# Technical Service Information

## ZF 5HP-24

### SLIPPING OR NO FORWARD ENGAGEMENT

Figure 1

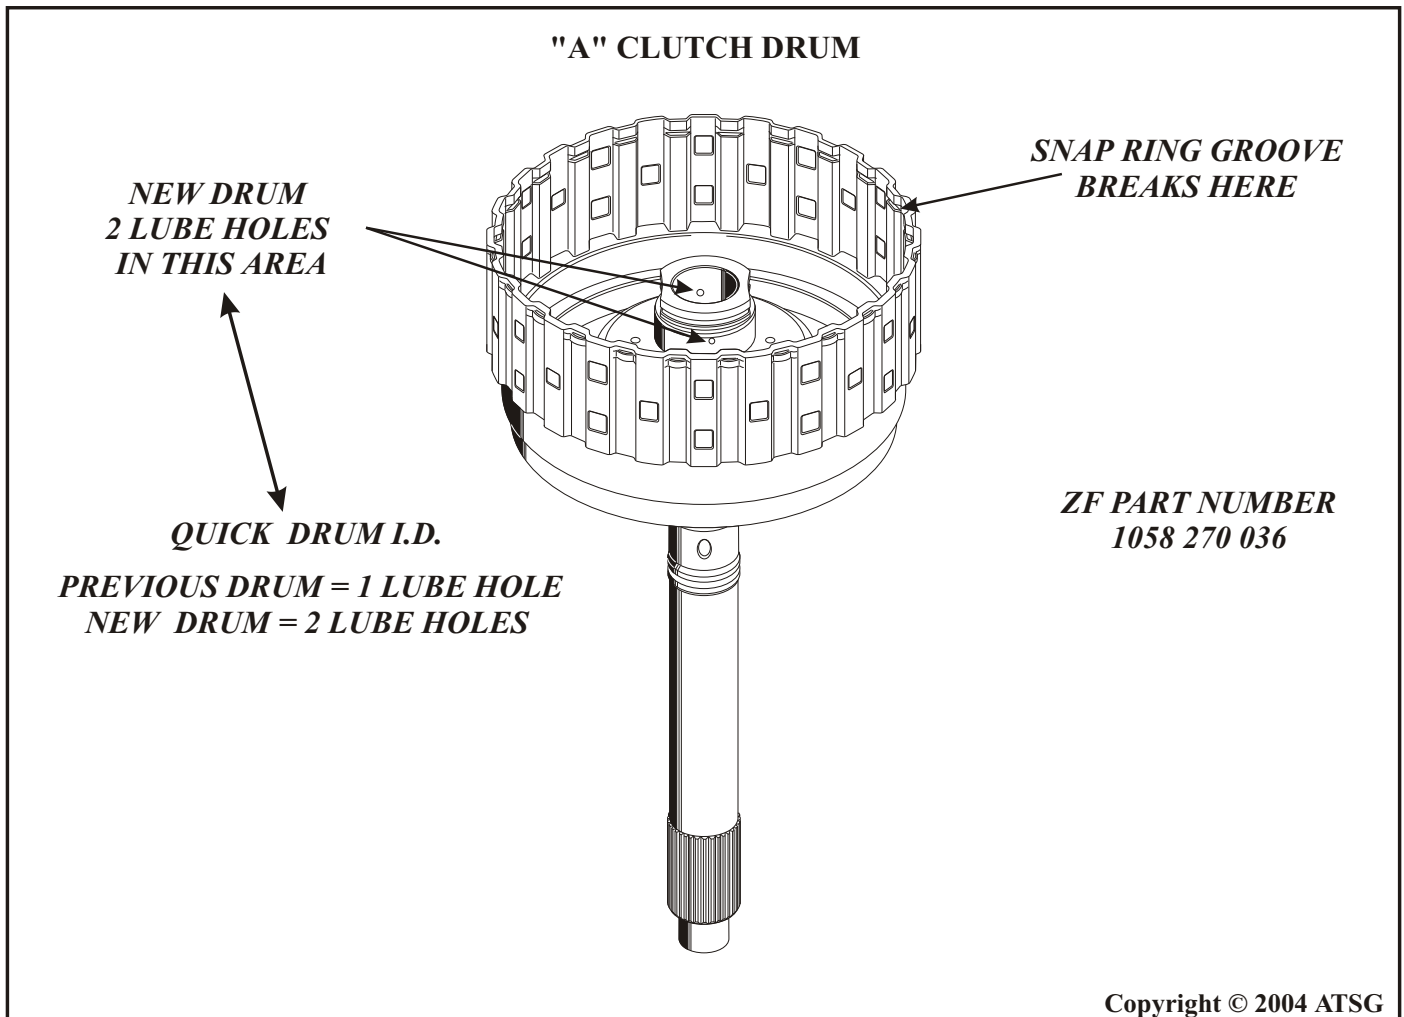
**COMPLAINT:** Vehicles equipped with the ZF 5HP-24 transmission may exhibit a Slipping or no Forward engagement.

**CAUSE:** The cause may be, a broken snap ring groove in the "A" Clutch Drum allowing the "A" Clutch to slip, as shown in Figure 1.

**CORRECTION:** Replace the "A" Clutch Drum with the updated drum available from ZF.

A CLUTCH DRUM (ZF part number).....1058 270 036
